A
TRANSNUCLEAR
AN AREVA COMPANY

April 20, 2010
E-29128

Subject: Revision 2 to Transnuclear, Inc. (TN) Application for Revision 3 to Certificate of Compliance No. 9302 for the Model No. NUHOMS[®]-MP197 Packaging – Response to Request for Additional Information (Docket No. 71-9302, TAC No. L24336)

Figure 7-3.1

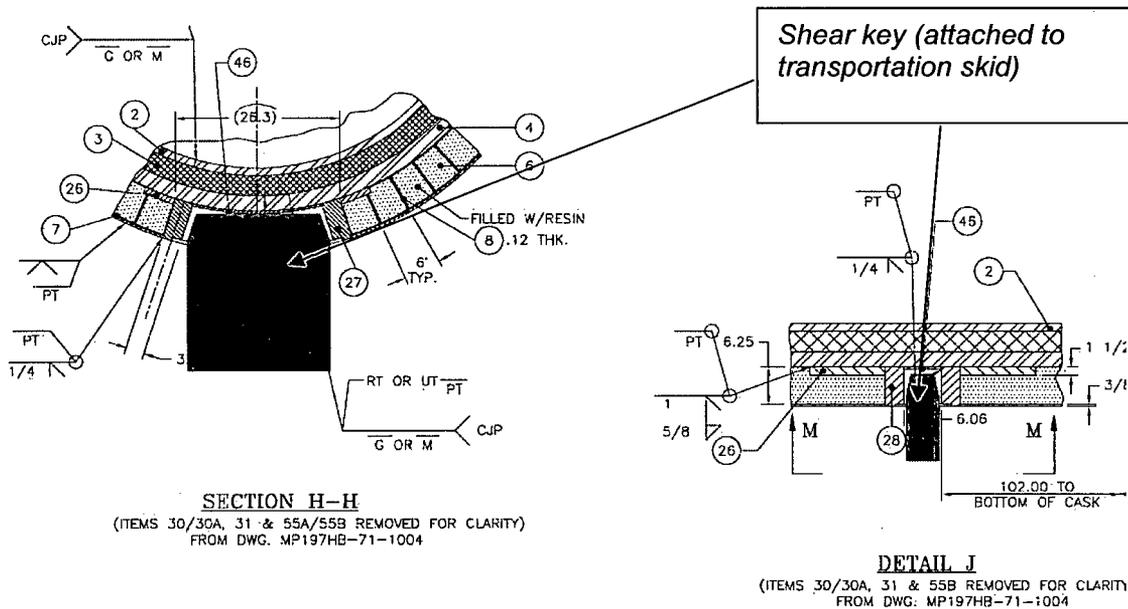
The shear key plug is not installed before the cask is placed in a horizontal position and secured on the platform (e.g., before transport), and is not used during transport, because of the presence of the transport skid shear key, which serves to resist the longitudinal accelerations of the cask during transport.

To be more specific, in the transport configuration, the shear key, which is part of the transport skid, fills the space shown on section H-H and detail J of SAR drawing MP197HB-71-1005 sheet 1 (please see Figure 7-3.1 below).

The shear key plug is only installed after the cask has been lifted from the skid and upended/rotated to a vertical position. Its purpose is to provide neutron shielding in the void that was previously filled by the shear key during transport.

SAR Chapter A.1, Appendix A.1.4.10 drawing MP197HB-71-1002 is revised to specify the same material as the rest of the cask neutron shield (Vyal B, item 6) for the shear key plug material (item 31). Therefore, a requirement for examining the shear key plug material to ensure that the plug is made with the same neutron shielding material as that on the cask side is unnecessary.
